Members
Panel on Planning, Lands and Works, and
Panel on Environmental Affairs
Legislative Council of Hong Kong
Jackson Road
Hong Kong

13 December 2005

**Re: Tamar and Central Harbour-front
Over-Capacity in Roadway Provision**

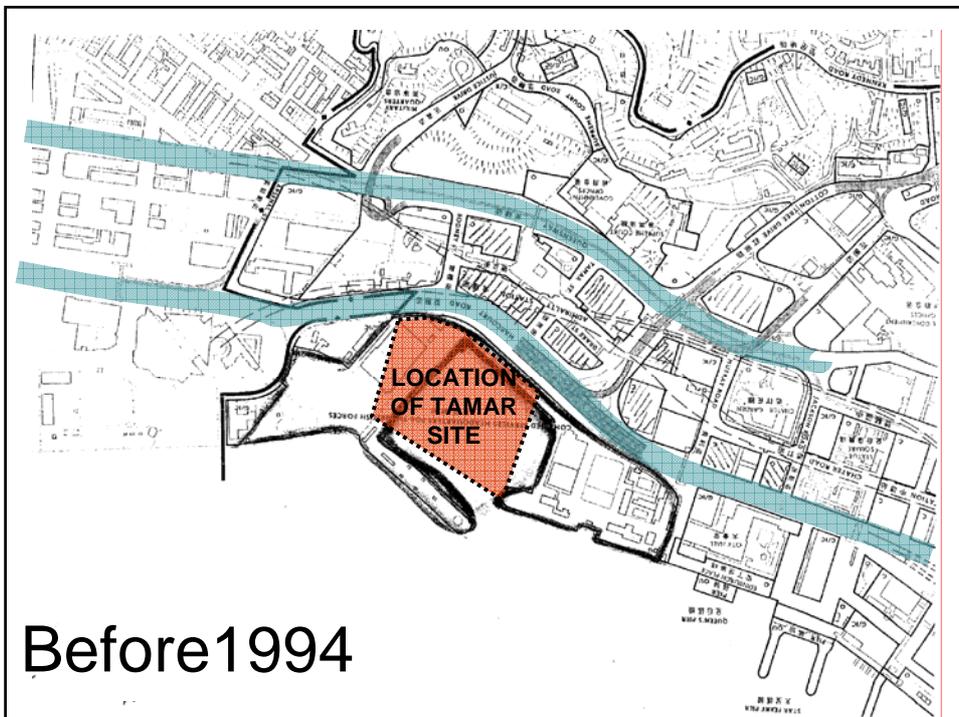
Since 1983 when the Study on Harbour Reclamation and Urban Growth identified a need for reclamation in Central and Wanchai the current densities of road development in the CRIII zone have been more or less fixed. The area has gone through more than half a dozen OZP changes since then but these densities have been maintained from the start. (Slide 2)

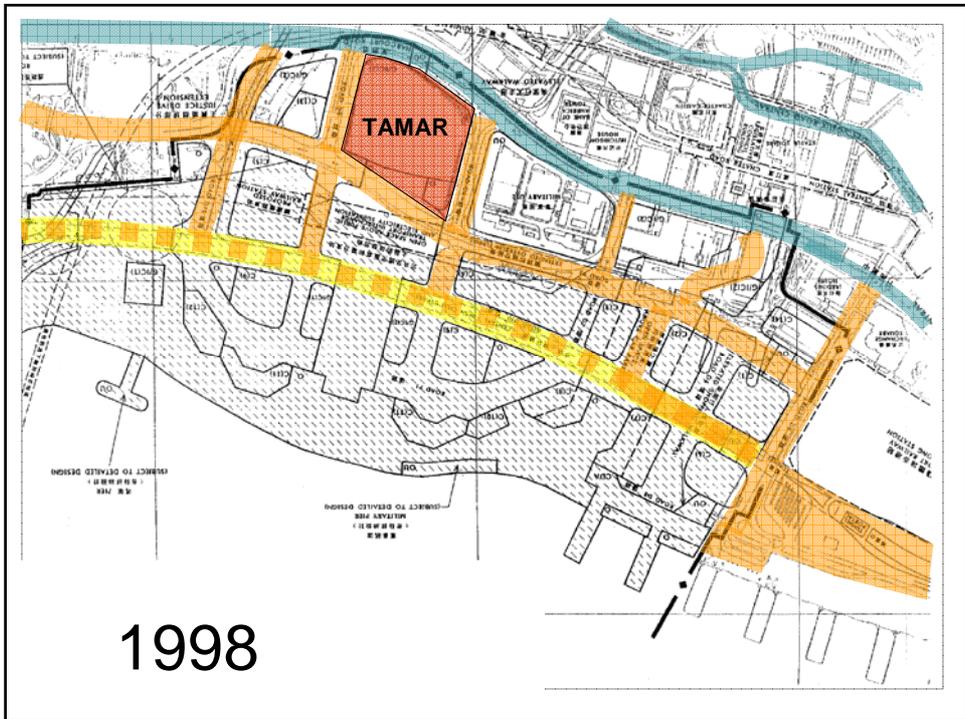
In 1994 when the planned reclamation extended 20% beyond its current alignment and the Tamar site was zoned for Commercial Development, the roadways planned for that full reclamation were already starting to be formed. (Slide 3)

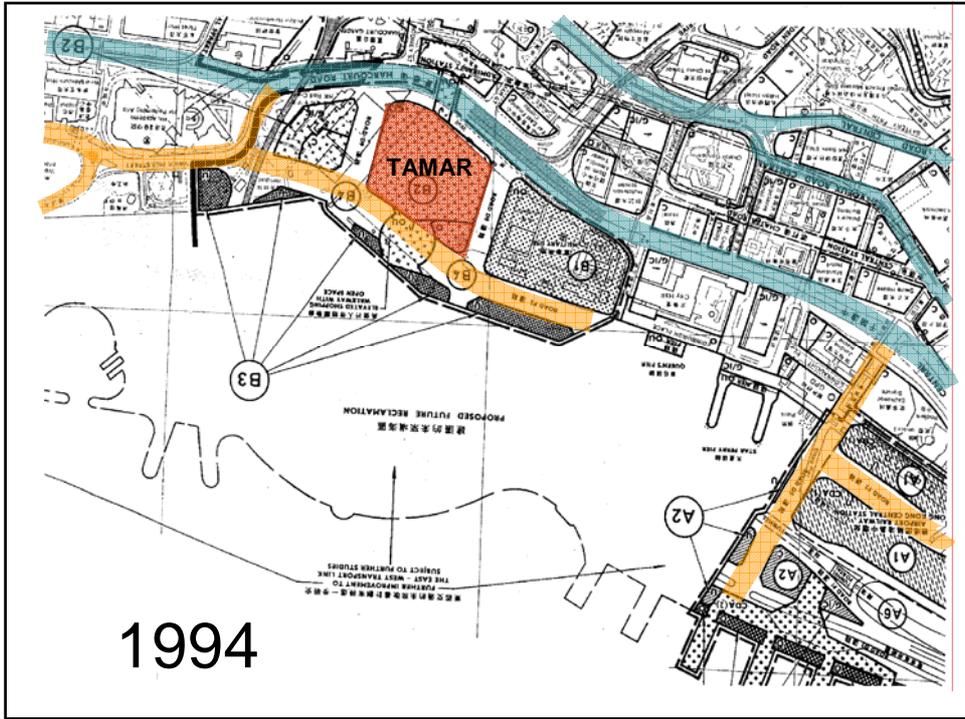
The plans for CRIII that were gazetted in 1998 give the clearest indication of what was intended for the site with development blocks including 14 Commercial Development sites and 6 Government Development sites extending towards the waters' edge with a network of major roads to accommodate and service this extensive plan for building construction. (Slide 4)

Tamar and Central Harbour-Front Over-Capacity in Roadway Provision

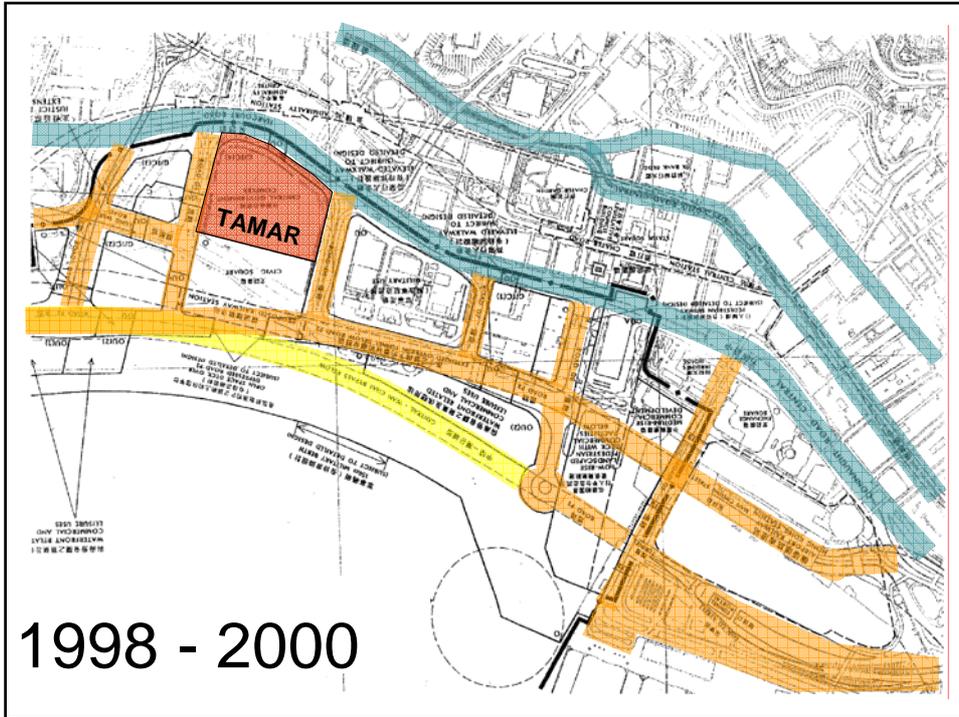
Roads designed to serve development planned in 1998 will still be constructed today, even though the buildings they were planned for no longer exist
